Supplemental Information: Grand Gulf Early Site Permit, SSAR Section 2.2, Nearby Industrial, Military and Transportation Facilities and Routes

NRC Staff Clarification Questions

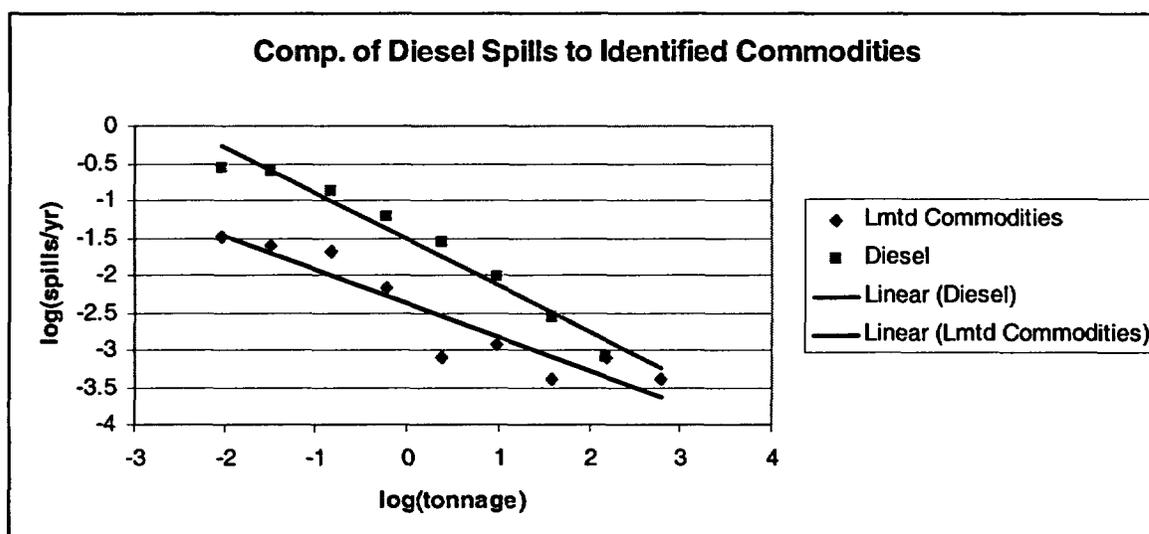
4. Page 22, 2.1 Spill Frequency Assessment: What is the basis for excluding spills involving commodities such as chlorine, coconut oil, diesel, lubricating oil ,etc? It is reasonable to expect a spill being the result of some sort of loss of tankage integrity (e.g., puncture, rupture). Hence, there is no apparent functional relationship between the type of commodity and the initiation of a spill in the event of a barge mishap. Exclusion of spills on the basis of commodity type can lead to a significant underestimating of the spill frequency.

There are two ways to have approached the spill frequency. One is on a spill per vessel basis. Then it would make sense to include all spill types, generate a per vessel frequency, and then multiply by the number of vessels. This is not what was done in the analysis of Reference 1. Rather, a spill of combustible contents per river mile frequency was calculated. The advantage of this approach is that it is not necessary to know the number of vessels involved. If, in the approach of Reference 1, a total spill per river-mile frequency was calculated by including chlorine, coconut oil, diesel, lubricating oil, etc., the results would then have to be multiplied by the portion of spills that involved the commodities of interest (e.g., gasoline, benzene, etc.), and the exact same final result would have been obtained. That is, the spill frequency may go up by a factor of X, but the portion involving materials of concern with would be 1/X, and these numbers would be multiplied together.

The question might then be asked why incident data for distilled fuel oil (DFO) was included in the analysis of spill frequency. DFO was included initially because it considered to be a possible plume or detonation source. Once DFO was out of the plume and detonation calculations, consideration was given to removal of DFO spill incident data from the spill database. However, the additional DFO spills (128 out of 255) are effectively cancelled out when multiplied by the fraction of vessels containing gasoline, benzene, etc. Since the DFO spills amounted to 128/256 (0.50 of the total) and the percentage of DFO is 0.40 of the total quantities shipped, it is conservative to keep the DFO data.

in the RAI Response text (Section H). If the total number of spills in each bin is ten times greater, then the curve fit will be an order of magnitude greater ($f = 10 \cdot 10^{0.4871 \cdot \text{LOG}(\text{tonnage}) - 2.7457}$). But then, when determining the fraction of spills that are one of the critical commodities, a multiplication factor of 1/10 would be applied, providing the same equation, $f = 10^{(-0.4871 \cdot \text{LOG}(\text{tonnage}) - 2.7457)}$ again.

Of course, the new spills may not increase each bin total by an identical ratio. If the new spills tended to be of a smaller size, they would tilt the curve fit such that it would have a more negative slope. Evaluation of diesel spills (all spills in the MislVslPoll database identified as diesel, some 2102 spills), show this is the case. A plot of curve fits to diesel spills and to the commodities previously identified is shown below. Since the diesel curve fit is steeper, it would be non-conservative to include diesel spills.
